Planning Permission for a Demolition of Existing Dwelling and Construction of Residential Development Located in Clonbrone, Lucan Newlands Road, Esker Hill, Lucan, Co. Dublin

CLARIFICATION OF ADDITIONAL INFORMATION

Reg Ref: SD22A/0390

Fig. 1 – Proposed Street Tree Planting, proposed by Gannon & Associates

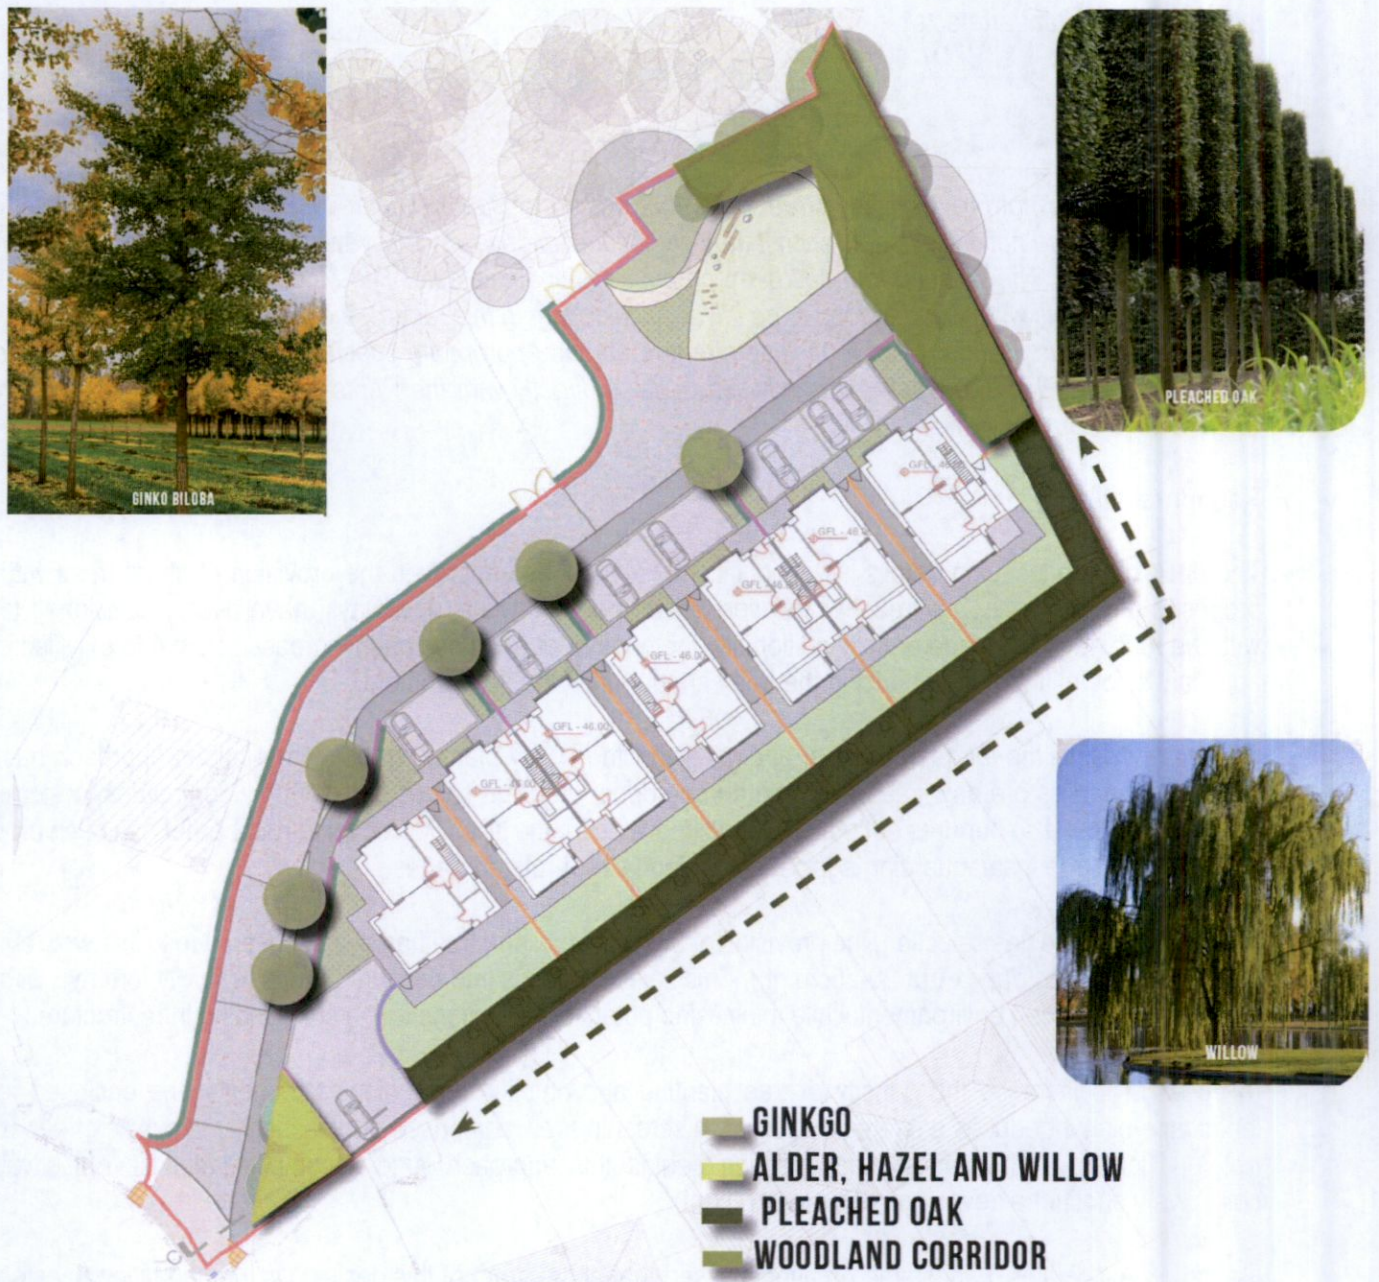
The applicant has not provided any street trees that are up to South Dublin County Council's standards. Street Trees proposed are not classified as such if they are located in driveways. Miyawaki planting is also not considered to be street trees. The planting that has been proposed is unacceptable. The Miyawaki planting proposed differs greatly from what is widely understood to be Miyawaki planting. In this regard, the Applicant is requested to provide a more appropriate Planting Plan to include street trees and appropriate species of planting. Prior to providing a revised Planting Plan, the Applicant is advised to liaise directly with the Parks and Public Realm Department of South Dublin County Council.

The enclosed landscaping details have significantly revised and improved the provision of street trees within the proposed development. The trees, which were initially located within driveways, have been repositioned to align with the road edge along the path. Additionally, the number of trees has been increased from 4 to 6, reflecting the applicant's commitment to enhancing the tree canopy within the development.

To further ensure the long-term health and vitality of the newly planted trees, a meticulous approach has been adopted. The trees are now integrated into rain gardens, a design choice that not only contributes to stormwater management but also nurtures optimal growing conditions for the trees. Moreover, a root barrier has been proposed to encircle the trees, safeguarding against any potential root-related issues.

Regarding tree species selection, the provision of the Ginkgo biloba tree has been chosen due to its favourable root ball characteristics (r/b, 4x trpt 20-25cm gt.). This selection takes into account the tree's ability to thrive within the proposed rain garden environment while minimising potential disruptions to the surrounding infrastructure.

In an effort to increase the density of tree planting and amplify the ecological benefits, the enclosed revised landscape plan introduces a strategic addition: a screening row comprised of pleached Quercus ilex trees (r/b, 3x trpt 14-18cm gt.). The overarching intention behind this approach is to accomplish multiple objectives that collectively enrich the development's environment.

Fig. 2 – Proposed Green Infrastructure Strategy

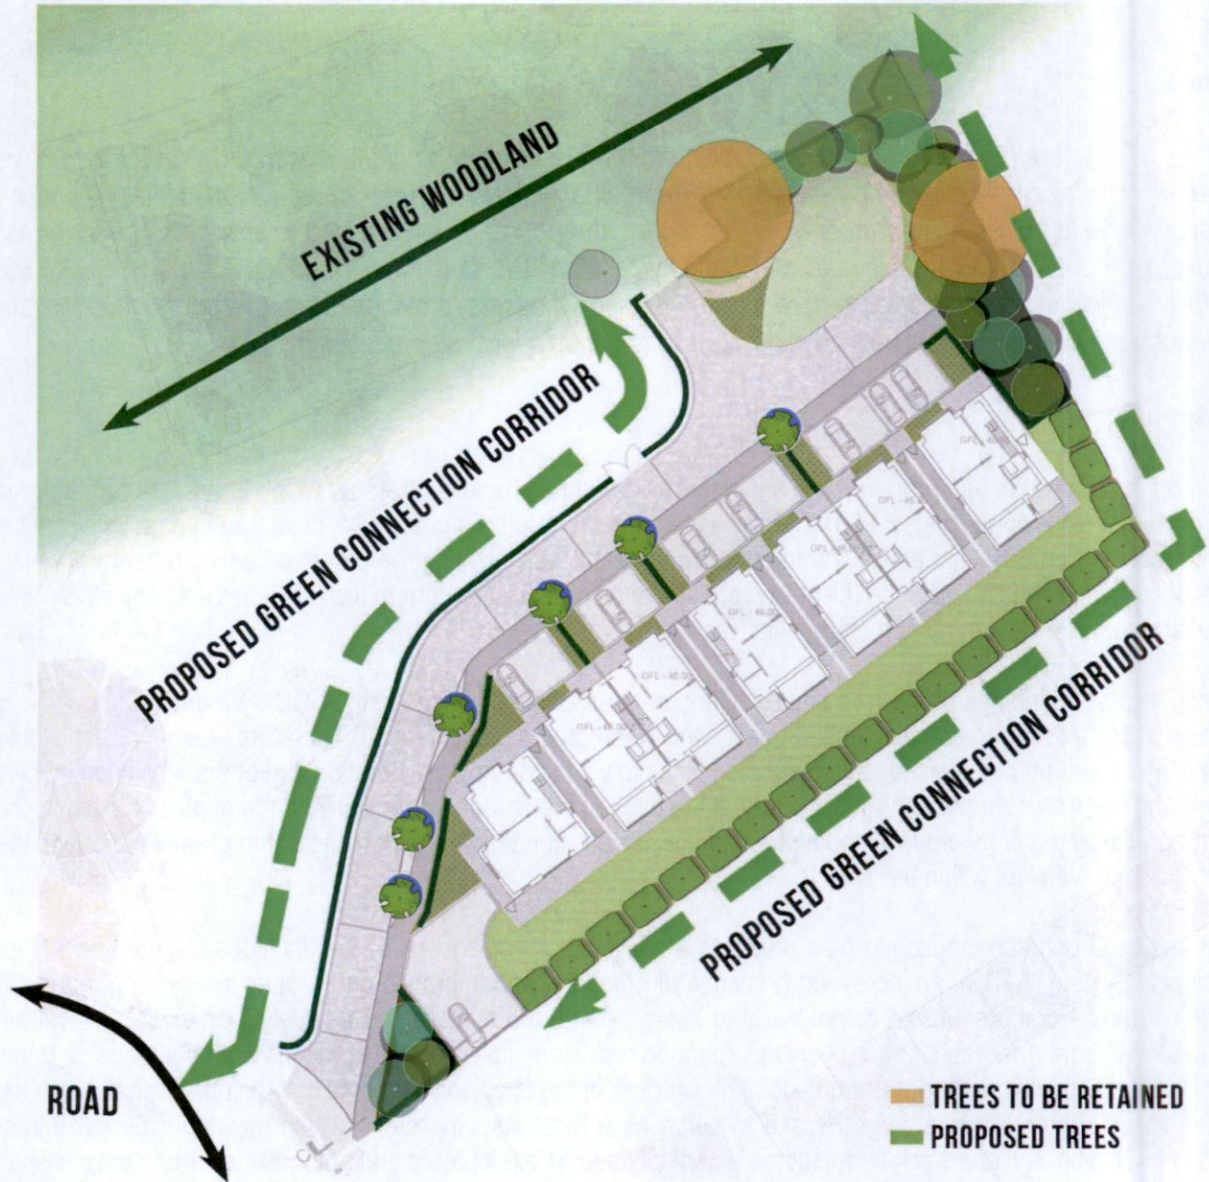
(i) *It is noted that the Applicant is proposing to remove virtually all of the existing Green Infrastructure that is currently on the site. This would result in the fragmentation of the Green Infrastructure Network and would be unacceptable to the Planning Authority. In this regard, the Applicant is requested to provide a Green Infrastructure Plan (to be coordinated with the revised Landscape Plan, Planting Plan, Drainage Plan and SuDS Plan) that includes objectives to protect or restore existing on site GI assets, provides for connection to local or primary GI corridors or includes elements which allow the site to act as a local steppingstone.*

Gannon & Associates has prepared the submitted Green Infrastructure Strategy, which is enclosed in their submitted landscape design report (pages 17-19). They assert that the strategic location of the site within the Liffey Valley Green Infrastructure Corridor emphasises the importance of seamlessly aligning the proposed development with this broader ecological framework. To achieve this, the proposed measures fully adhere to the principles and objectives set by both local and regional Green Infrastructure initiatives.

Recognising the findings of the tree survey, Gannon & Associates concur with SDCC's assessment that a significant portion of the existing trees have limited quality and value, and a short lifespan. Therefore, keeping them would not be practical. The submitted revised landscape plan takes this into careful consideration and offers a solution by introducing screening trees along the southern boundary at the back of the gardens. Additionally, the applicant is firmly committed to re-establishing a Coniferous Woodland along the eastern boundary, a commitment that greatly enhances the Green Infrastructure Network within the site.

The enclosed updated landscape plan presents a multifaceted enhancement that includes features of a Sustainable Drainage System (SuDS), an increased presence of greenery, and improved public open space. Importantly, this plan demonstrates a comprehensive commitment to safeguarding and revitalising the existing on-site Green Infrastructure (GI) assets. Furthermore, it meticulously incorporates provisions that promote connectivity to both local and primary GI corridors, effectively creating a harmonious link with the broader ecological context. A pivotal aspect is the deliberate inclusion of elements that enable the site to serve as a local stepping stone within the larger Green Infrastructure Network. This holistic approach underscores a dedication to a development that embodies environmental responsibility, enhanced aesthetics, and a mutually beneficial relationship with the surrounding ecosystem.
